Synchronous Auto-Negotiation Proposal

Howard Baumer
Ali Ghiasi

Figure 37-6 Modification #2 Tx Training

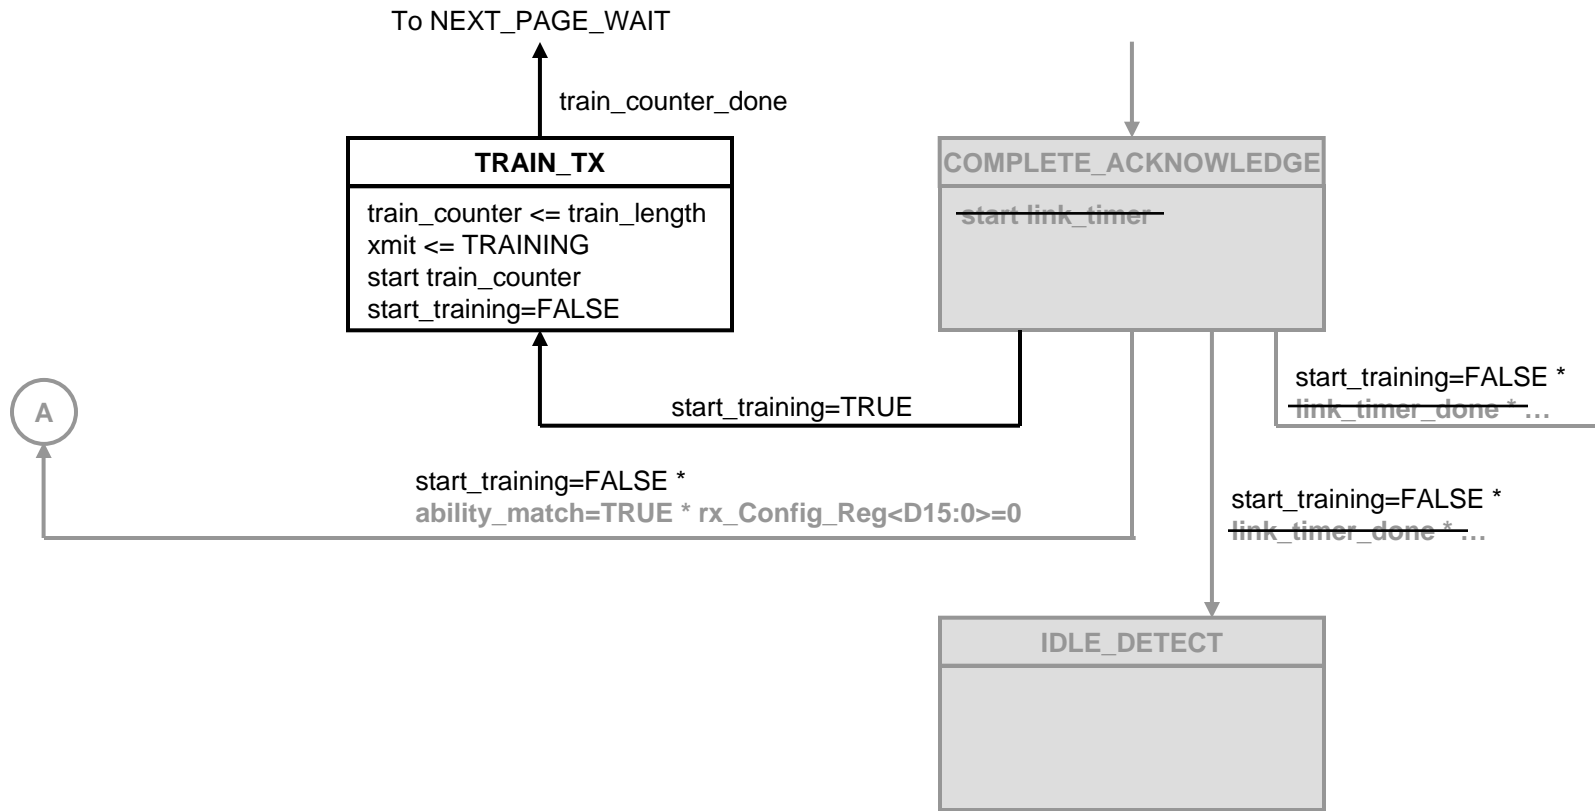
Greyed = Existing
Black = New

Figure 37-6 Modification #2

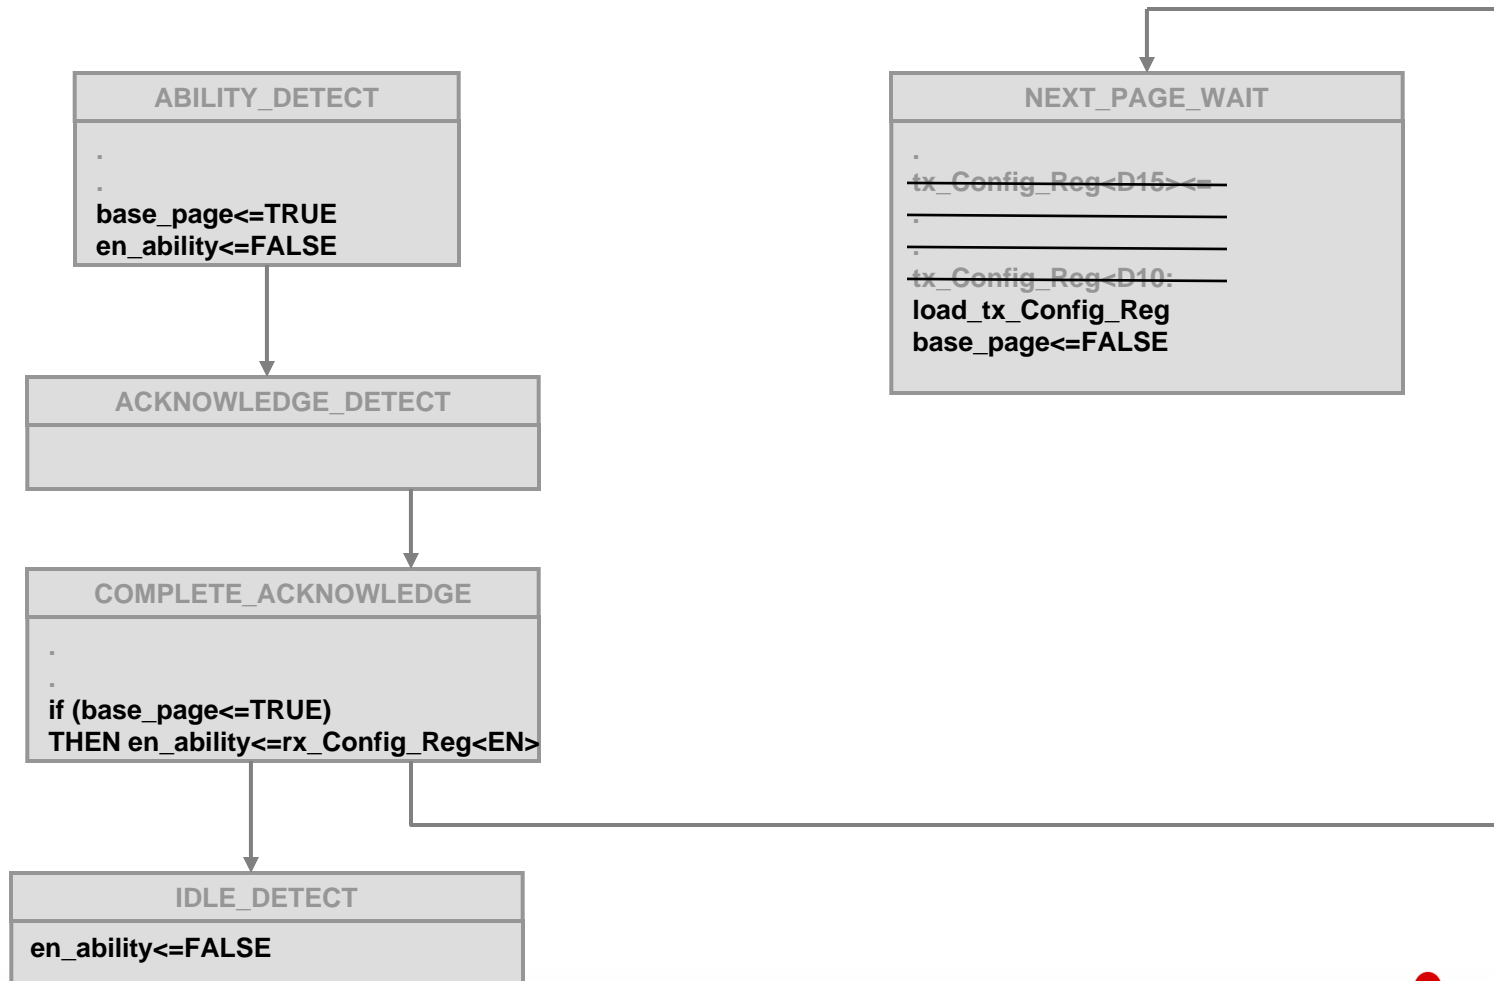
Extended Next Page

Greyed = Existing

Black = New

Figure 48-9 Modification

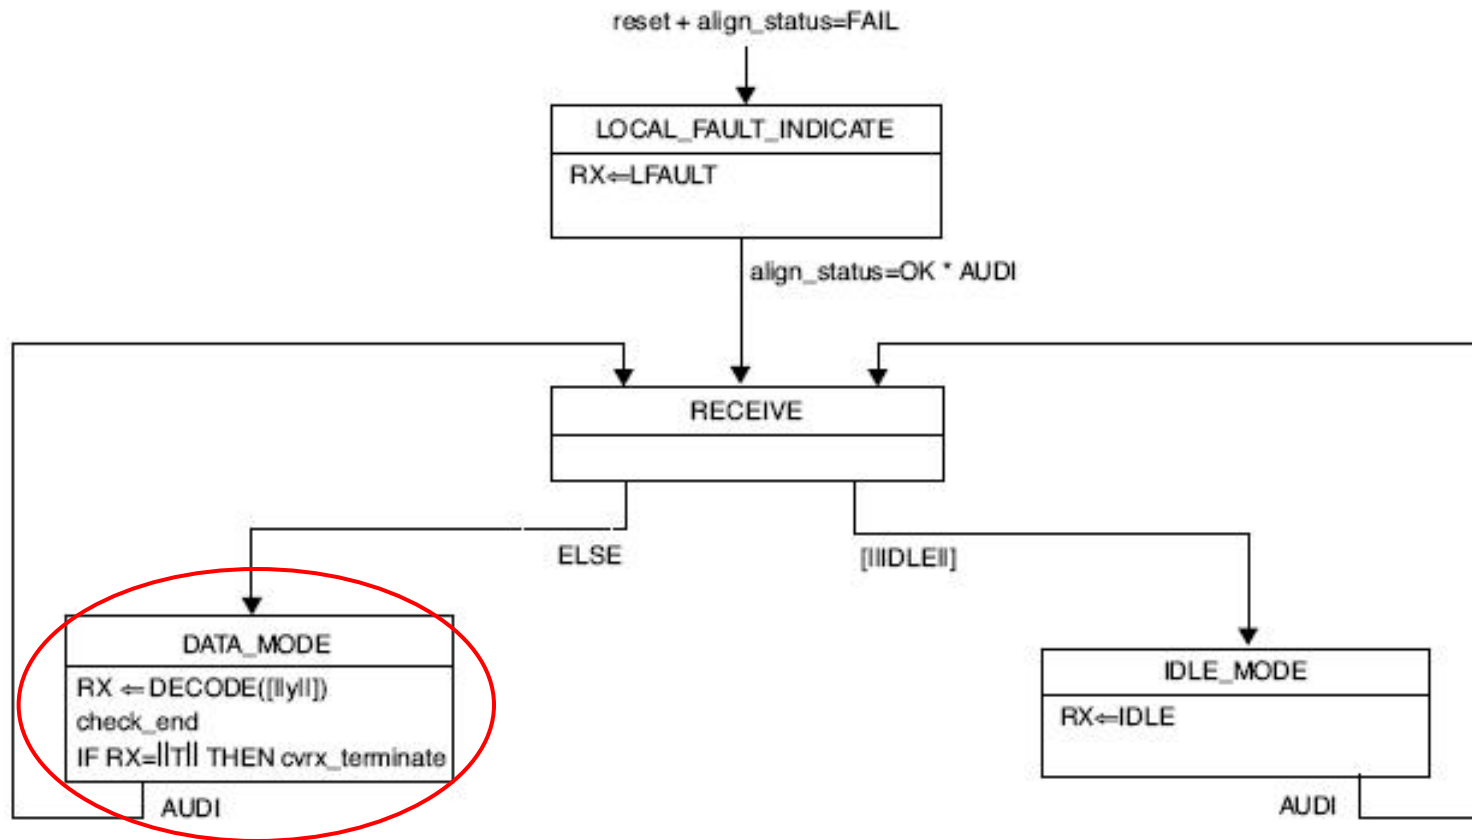
```
DATA_MODE
RX<=DECODE(||y||)
IF RX=|C| THEN
  rx_Config_Reg<=RX<D23:D8>
  RX<=|IDLE|
ELSE
  check_end
  IFRX=|T| THEN crvx_terminate
END
```
